Access Compliance Report

Public Rights-of-Way

(Pedestrian Signals)

Intersection ID: N/A	Main Street:	Cross Street: N/A	Location: N/A
ADA ID: 6E59A1673399	Signal Type: Two Push Buttons-Non APS	Overall Compliance: No	Severity Score: BTN 1:N/A BTN 2: N/A No BTN: N/A
Codes/Mitigation Info/Possible Solution		Field Measurements/Component Compliance

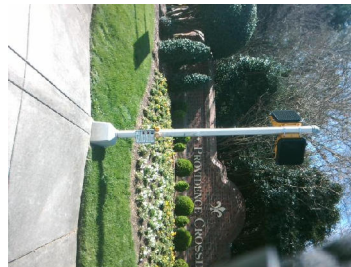
PROW/ADA: TMUTCD 4e.08, R404.2, R404.3

N/A	B 1 Clear Xing Direction?	Yes	N/A	B 2 Clear Xing Direction?	Yes
	B 1 Crossing Direction	To NE		B 2 Crossing Direction	To N
Yes	B 1 DistanceTo XWalk (in)	0.0	Yes	B 2 DistanceTo XWalk (in)	36.0
No	B 1 DistanceTo Curb (in)	110.0	No	B 2 DistanceTo Curb (in)	110.0
Yes	B 1 Diameter (in)	2.0	Yes	B 2 Diameter (in)	2.0

Possible Solutions: Replace Signal Push Button With APS Button on New Post. Remove & Relocate Sign.
